ANCHORAGE, ALASKA
AR No. 2022-287

1 **A RESOLUTION OF THE ANCHORAGE MUNICIPAL ASSEMBLY APPROVING**
2 **CHANGES TO THE 2021 BASIS-OF-DESIGN CONCEPT SUBMITTED AND**
3 **RECOMMENDED BY THE PORT OF ALASKA MODERNIZATION PROGRAM**
4 **AND DESIGN ADVISORY BOARD THAT WILL GOVERN ONGOING DESIGN**
5 **EFFORTS FOR THE PORT OF ALASKA GENERAL PURPOSE CARGO**
6 **TERMINALS.**

TO: Mayor Dave Bronson
FROM: Steve Ribuffo, Chair of the PAMP Design Advisory Board (DAB)
SUBJECT: Recommendations of the PAMP Design Advisory Board from Their August 2, 2022 Meeting

Proposed Changes to Design Basis

Terminal 1
Concept
Approved in
June 2021

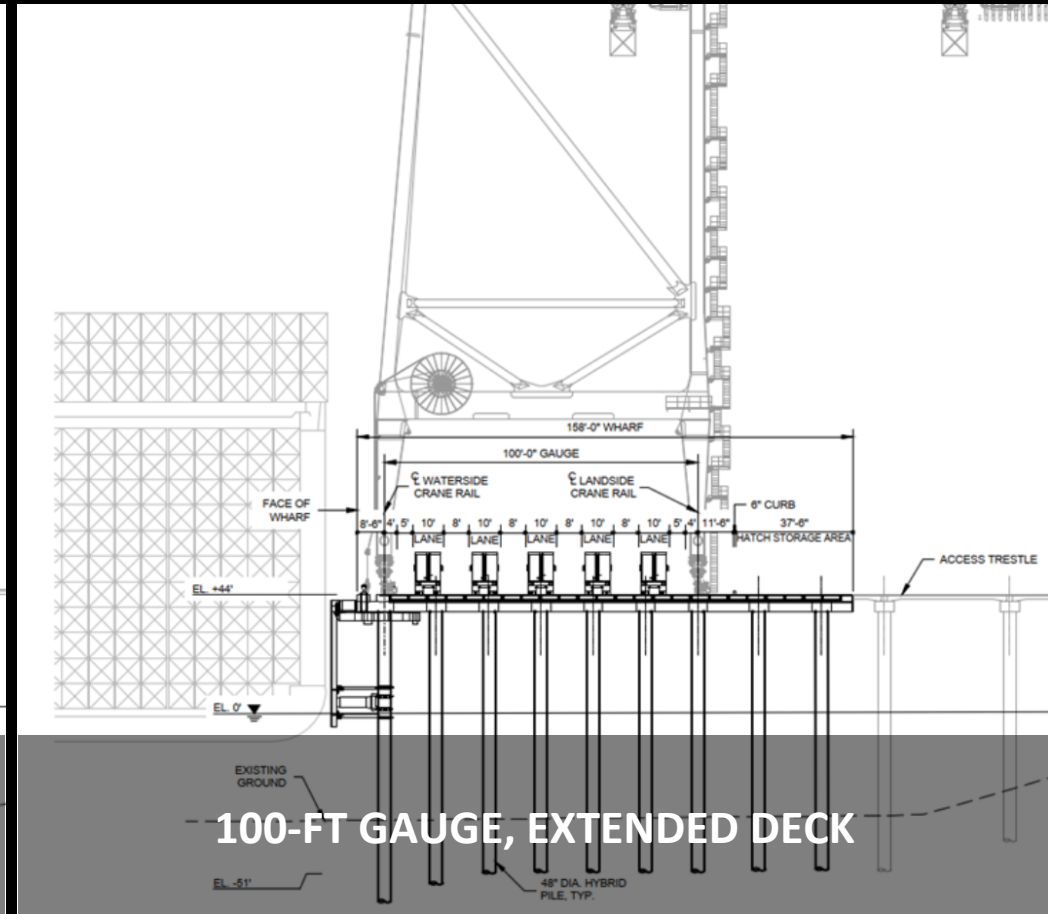
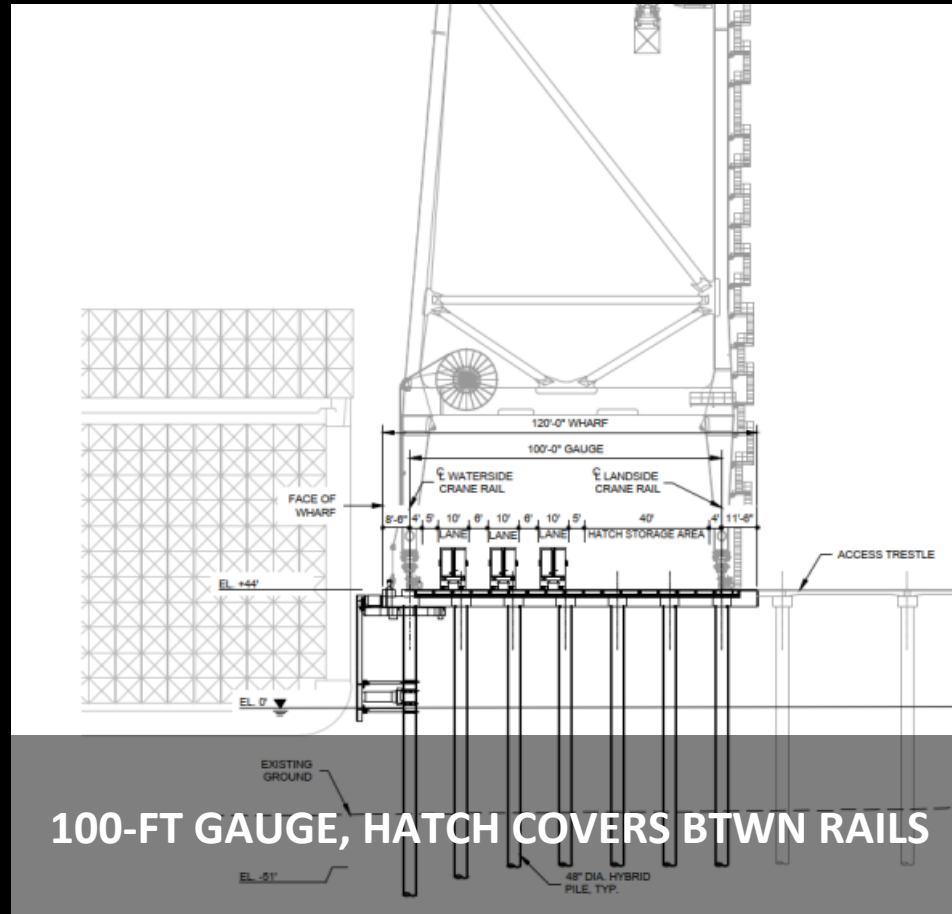
- Standard crane size – Easier to acquire, replace and/or resell
- Improved seismic stability over narrower cranes
- Sufficient reach to fully service all planned design vessels
- Improved air draft for larger vessel classes
- Power generation capabilities
- Understood to be the operational preference of Matson
- Recommended by Program Management Office and Peer Review
- Operational preference of MOA/POA, the Port owner

- **Terminal 1**
 - Confirm 100-ft gauge cranes
 - Confirm acceptance of core 15% concept design
- **Terminal 2**
 - Restore continuous berth face to concept design
- **Defer decision on following design features:**
 - Hatch cover storage
 - Seismic design criteria at Terminal 2
 - Width and rail accommodations at Terminal 2
 - Location of temporary fuels unloading point

Terminal 1 Current Concept (15%) Design

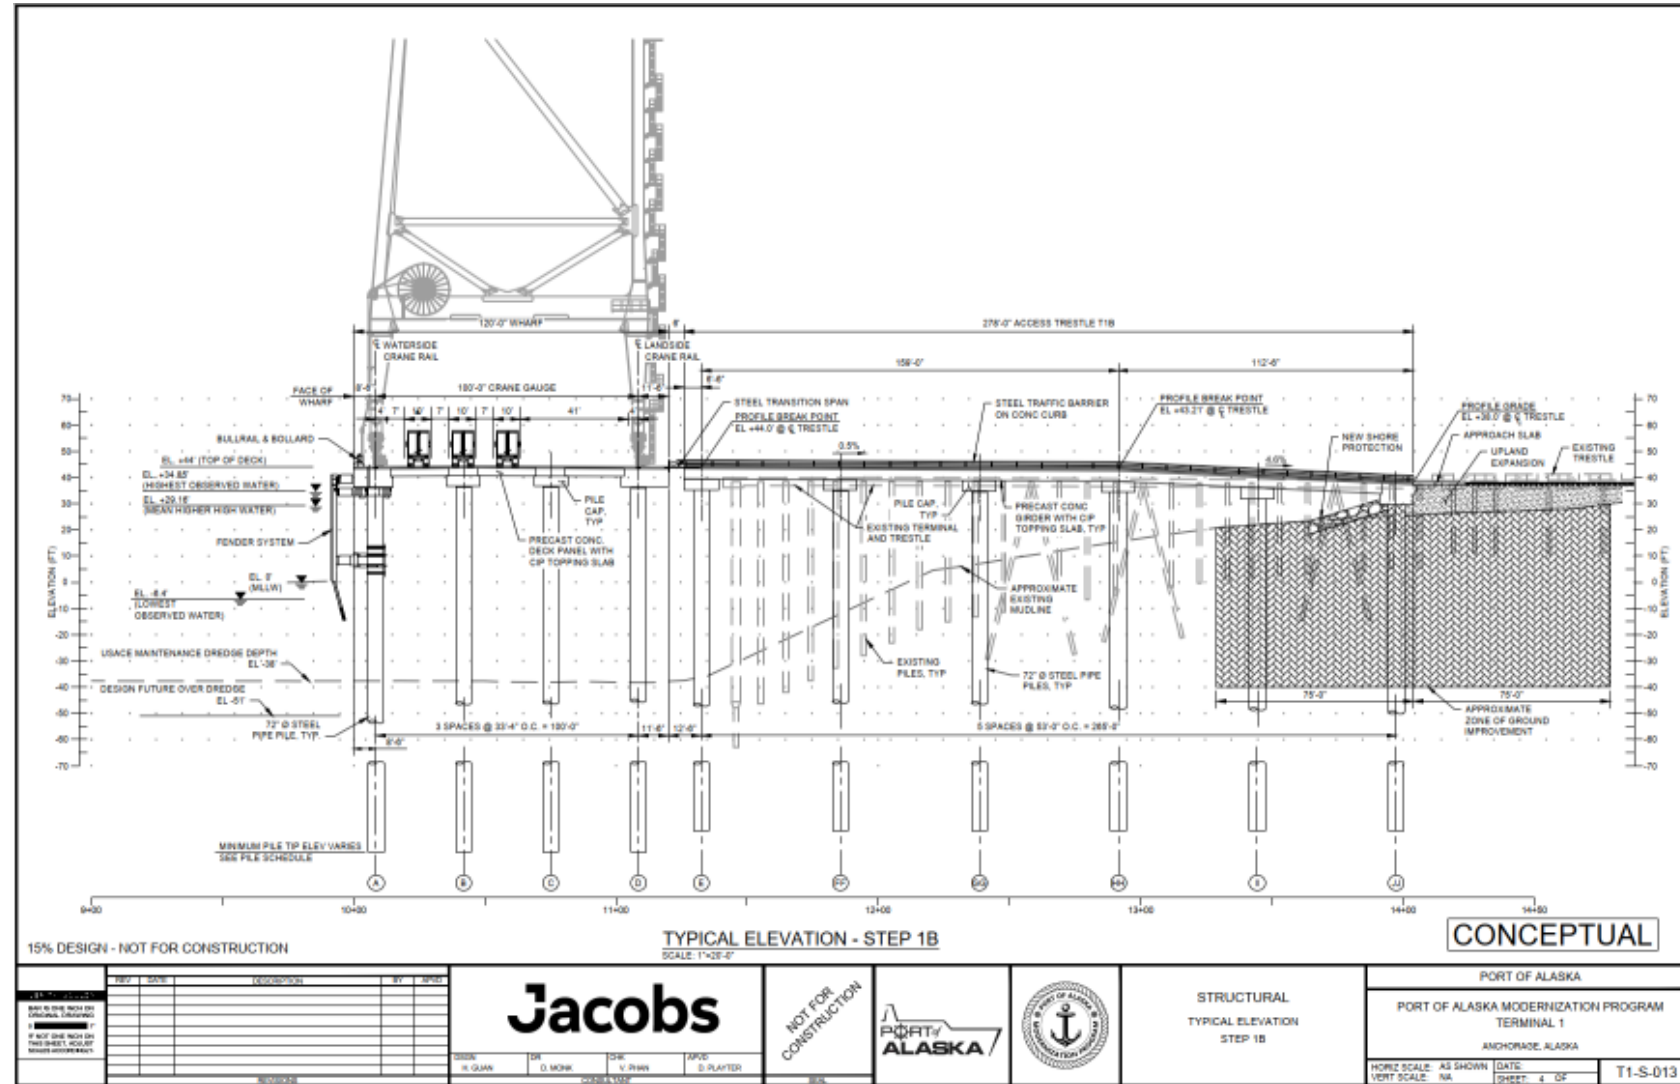
- Confirm 100-ft-gauge crane as design basis
- Approve plan to advance to next stage of design with core structure
- Revisit hatch cover storage after further study by Jacobs and Matson independently

T2 Modified TOTE 2021 Concept

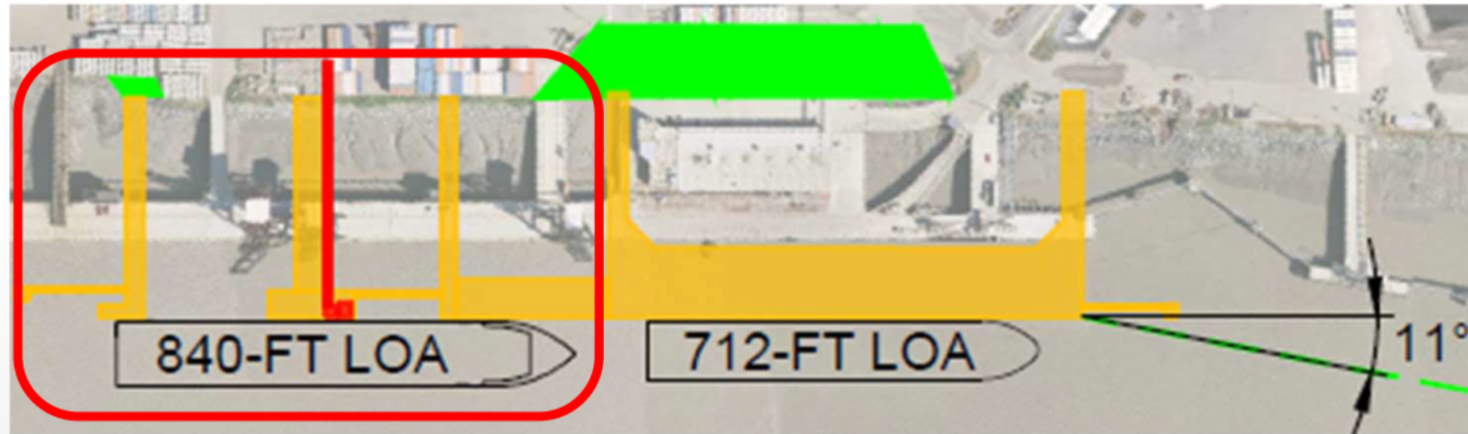
- Maintain continuous berth face in concept design
- Consider reducing seismic design criteria of berth
- Consider widening platform and adding 100-ft-gauge rails, i.e. continuing Terminal 1 geometry

- B. For Terminal 2 – To restore the continuous berth face to the concept design
